# The Light company

March 11, 1986  
ST-HL-AE-1621  
File No.: G9.17

South Texas Project  
Units 1 and 2  
Docket Nos. STN 50-498, STN 50-499  
Auxiliary Feedwater Requirements

Attached for your information and use is a copy of revised sections of the STP FSAR as transmitted to the NRC staff in Washington on March 6, 1986. These revised sections reflect the commitments as outlined in the referenced letter.

Figure 10 A-6

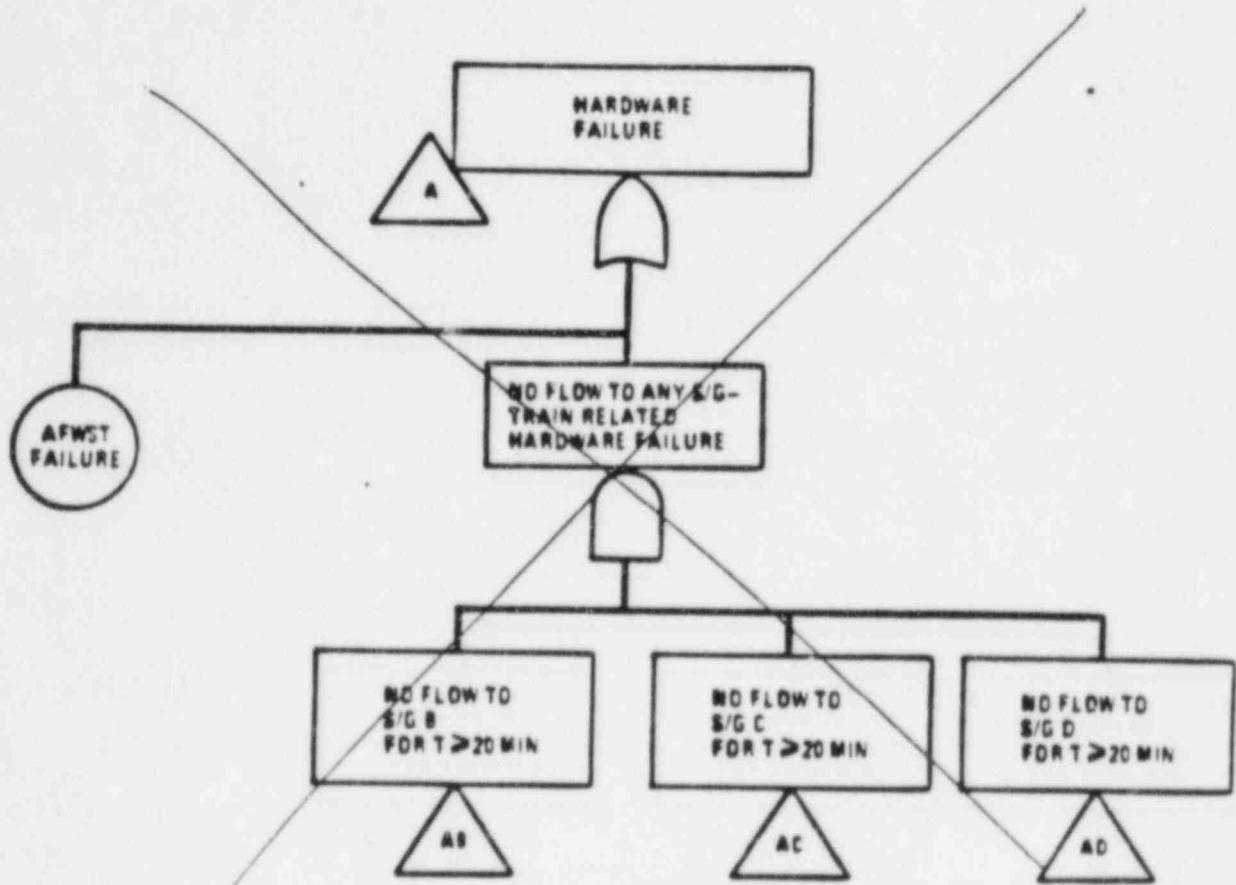
*delete*

Figure 10 A-7

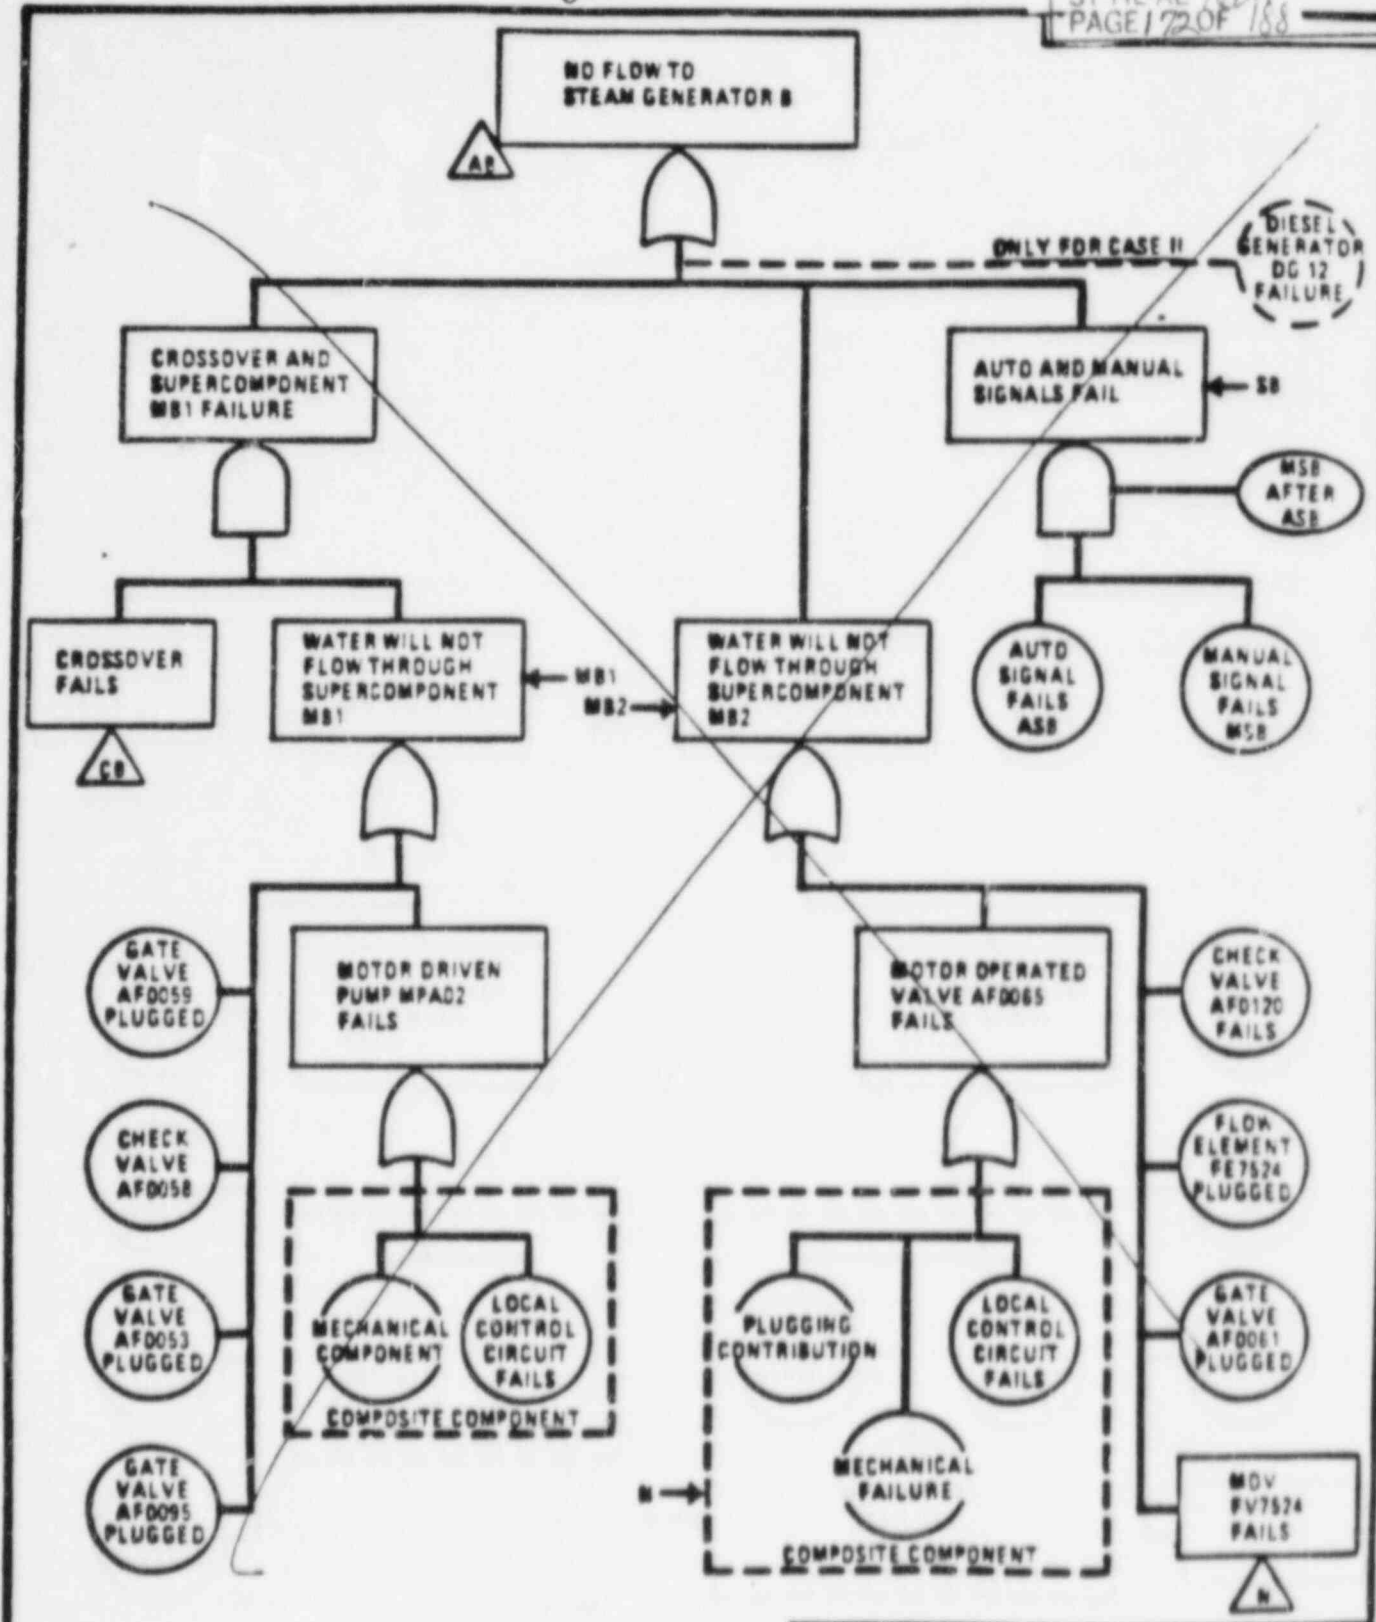
delete

Figure 10 A-8

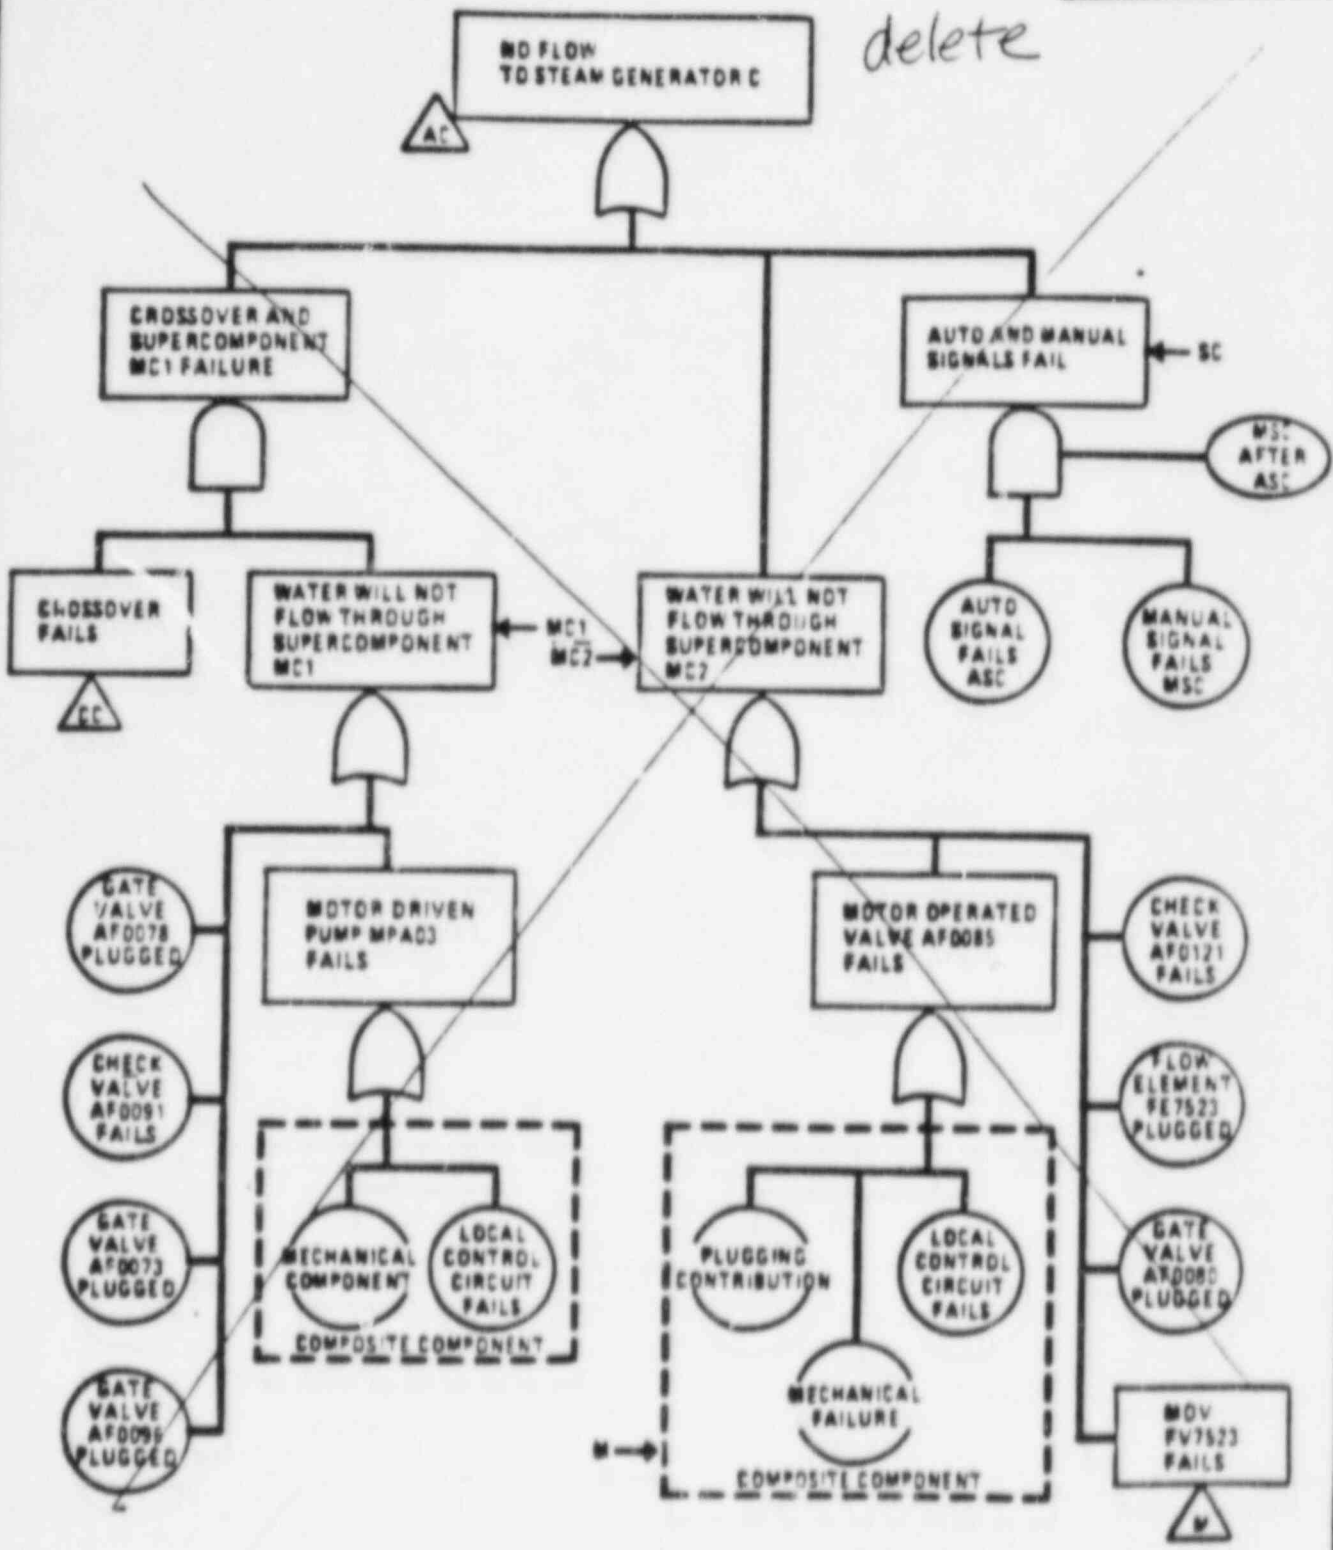
*delete*

Figure 10 A-11

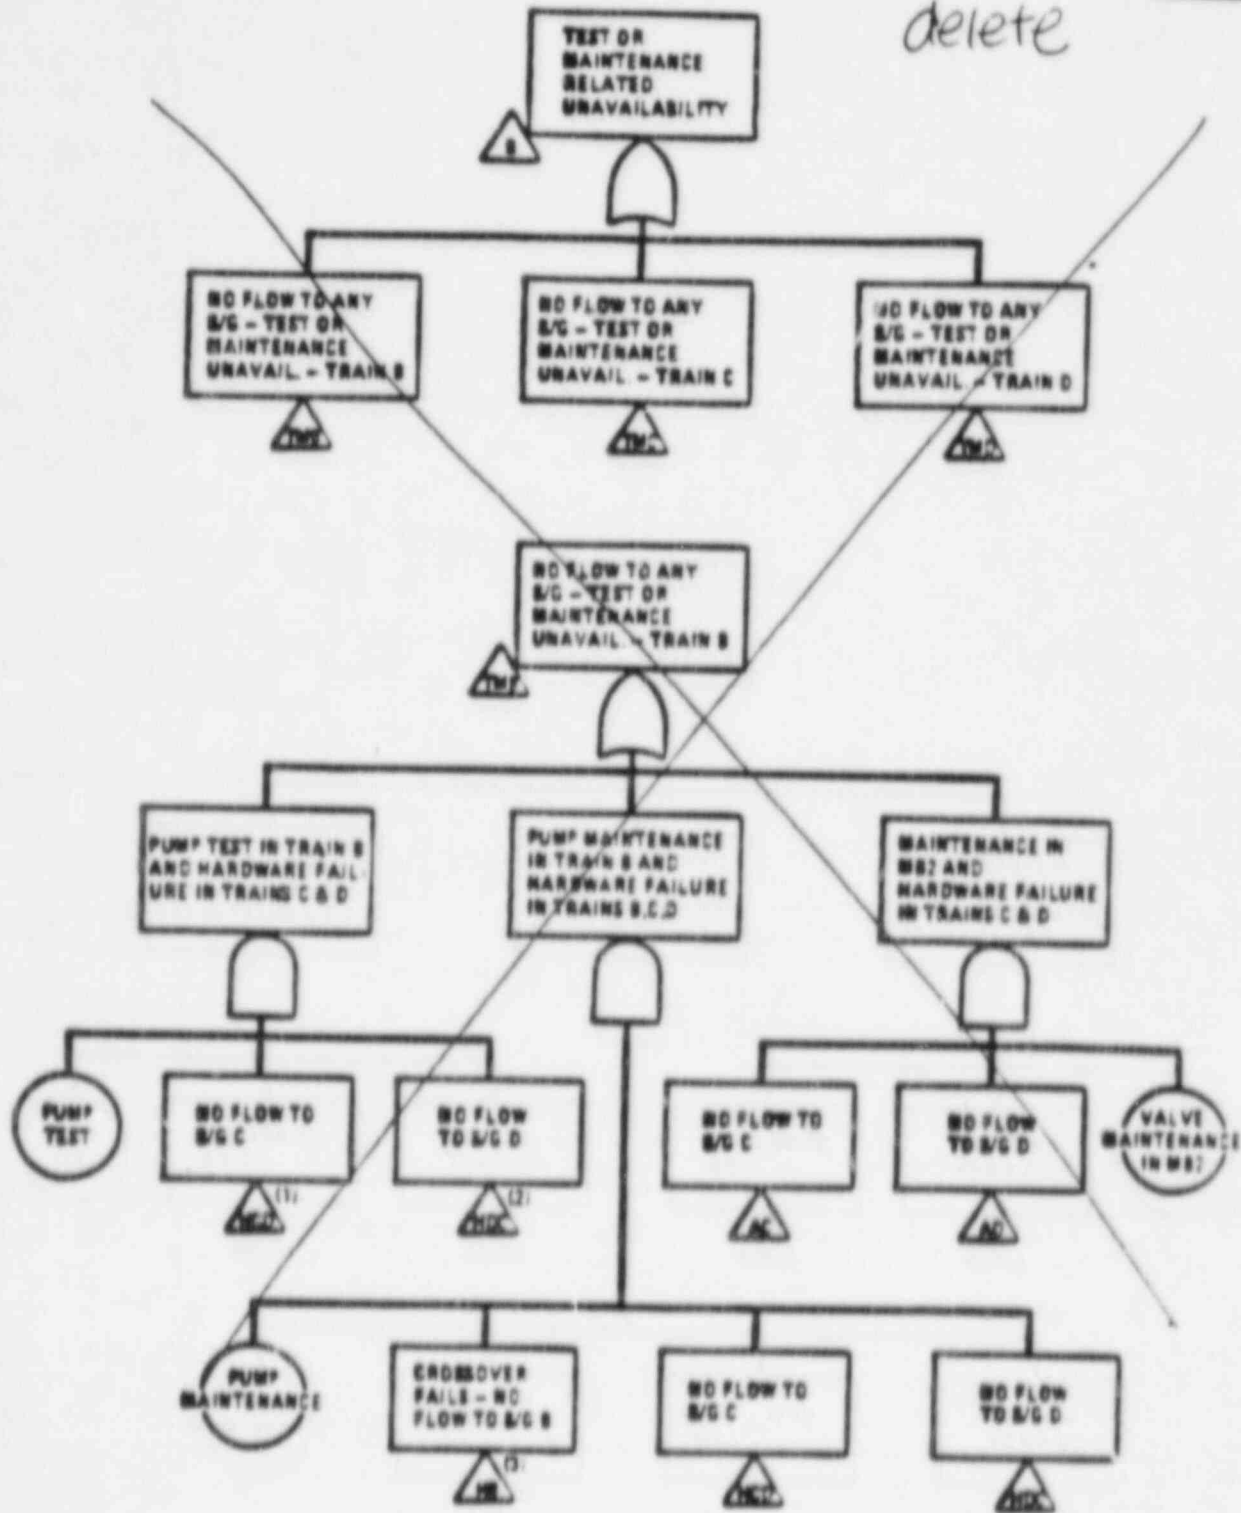
*delete*

Figure 10 A-11

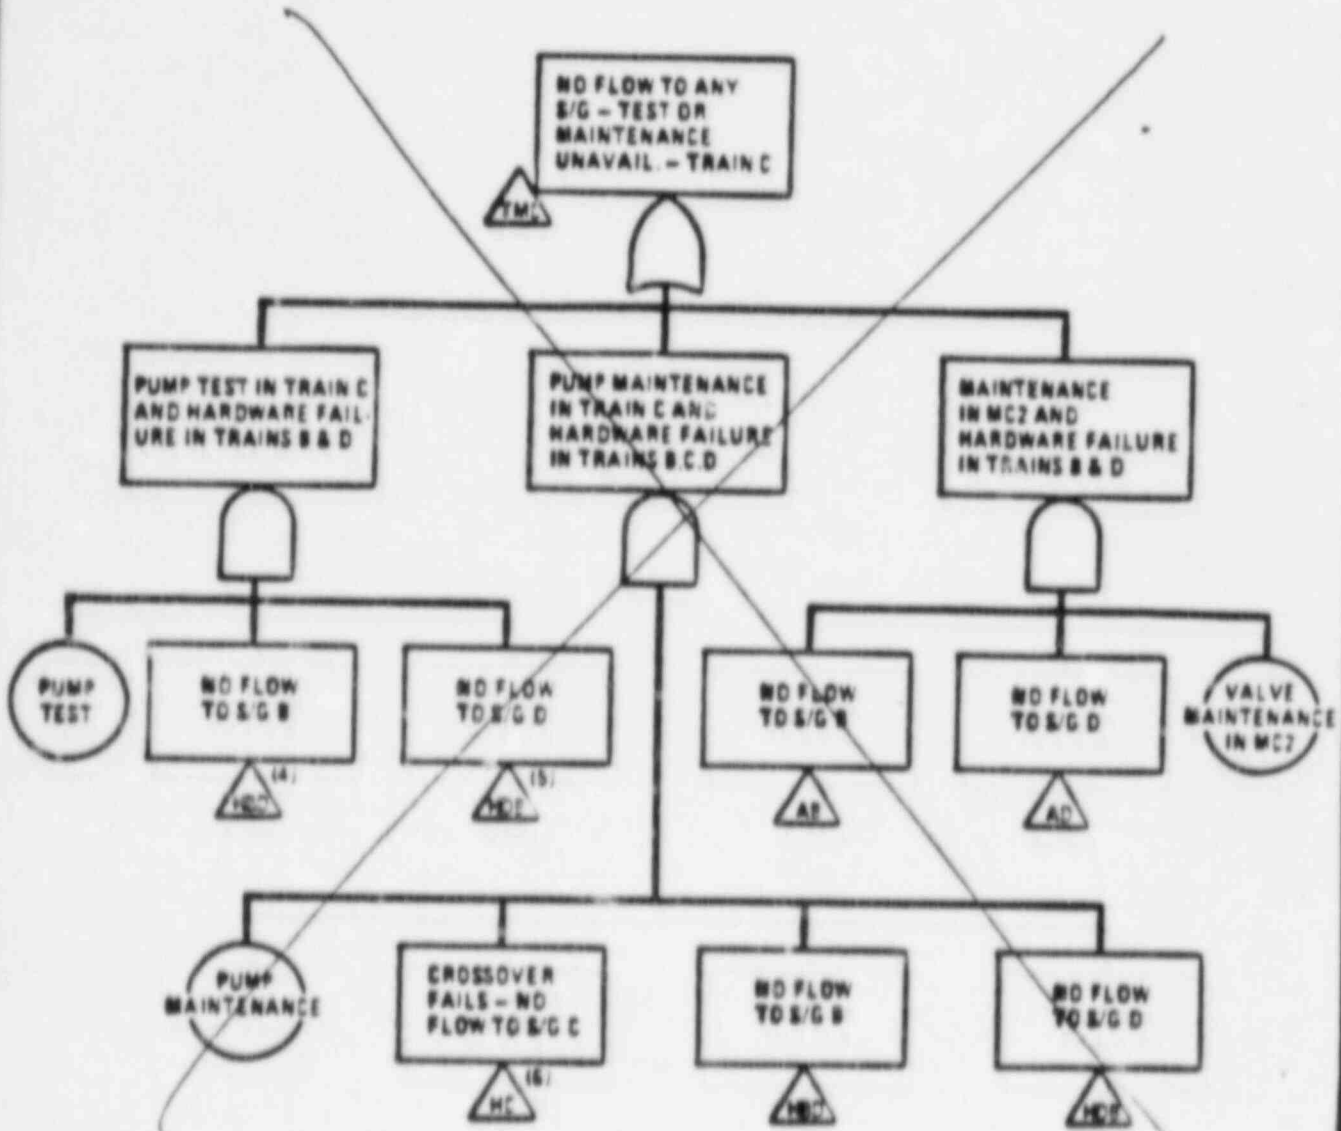
*delete*
